Project Name: Webster University-**ISB**

Copies	No.	Description
1 PDF	224213P02	(Submittal No.'s)
		(Cannon #22 4213.16-004) - (Paric #15051-) - (WES #607)
		➤ Commercial Urinals
		• American Standard Urinal - UR-1
		• Sloan Flush Valve
		• Wade Plate Type Wall Urinal Carrier

Letter of Transmittal

PROJECT NAME: Webster University ISB
 LOCATION: St. Louis Missouri
 CLIENT PROJ. NO.: N/A
 WES PROJ. NO.: 607
 SPEC SECTION: 224213.16
Commercial Urinals
 SUBMITTAL ITEM: See Below -

401 Plate Type Wall Urinal Carrier

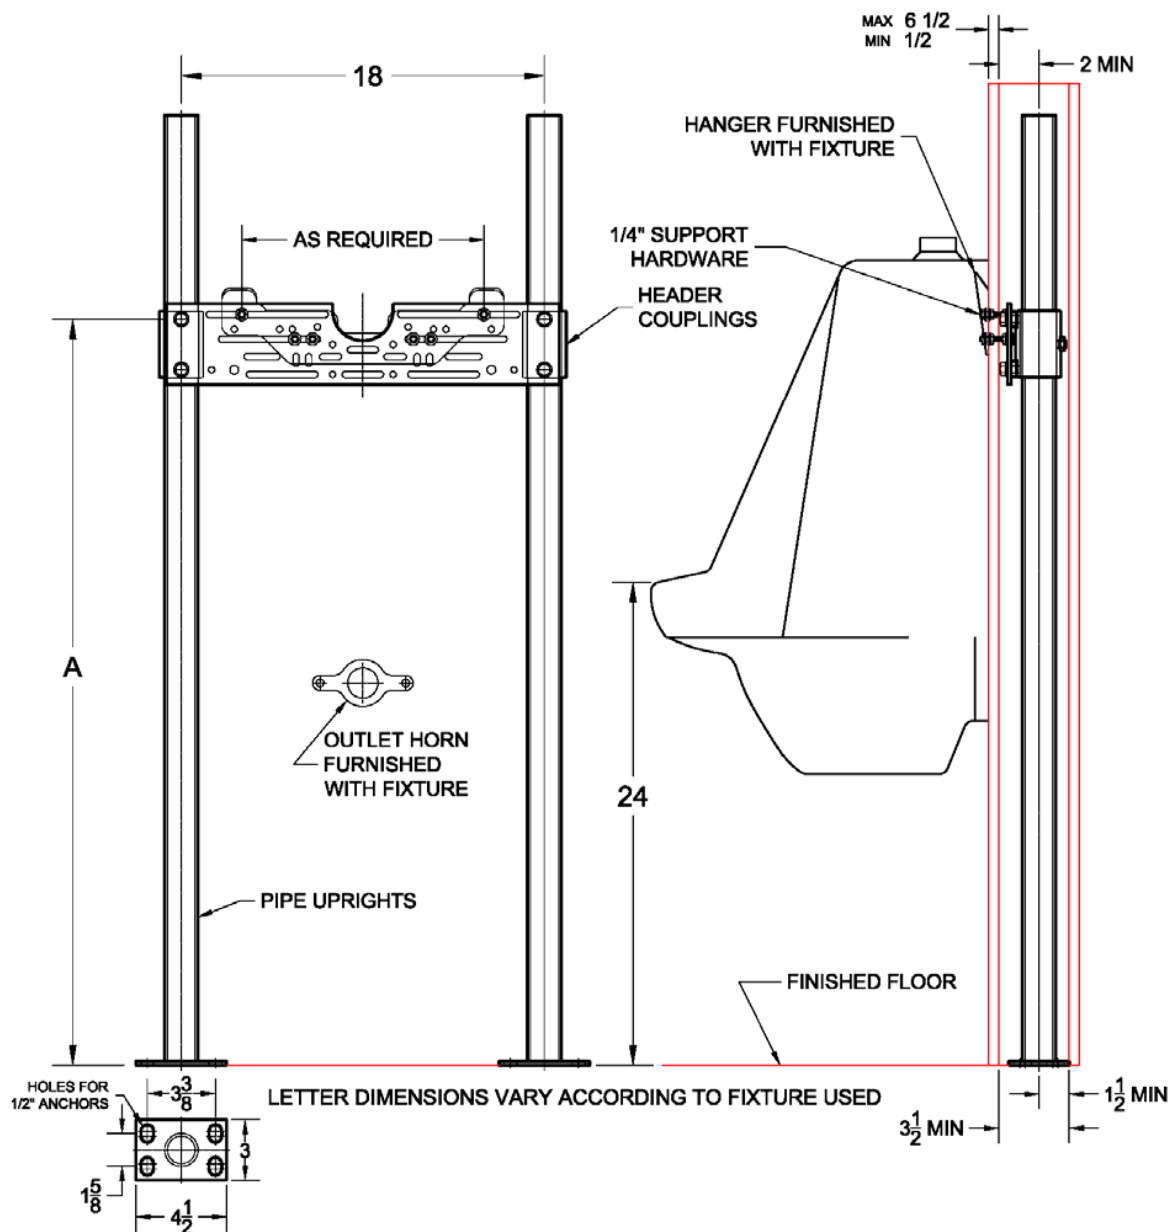
NEC	MCN	AAR	REJ	REV	NO EXCEPTION TAKEN	
					MAKE CORRECTIONS NOTED, NO RESUBMITTAL:	
					AMEND AND RESUBMIT	
					REJECTED, SEE REMARKS:	
					REVIEWED ONLY	
					ITEM	REMARKS
Urinal UR-1						
X					Urinal American Standard Model 6590.001	
X					Flush Valve - Sloan Model 8186-0.5	
X					Plate Type Wall Urinal Carrier Wade Model 401	Verify correct mounting height for ADA accessible installation.
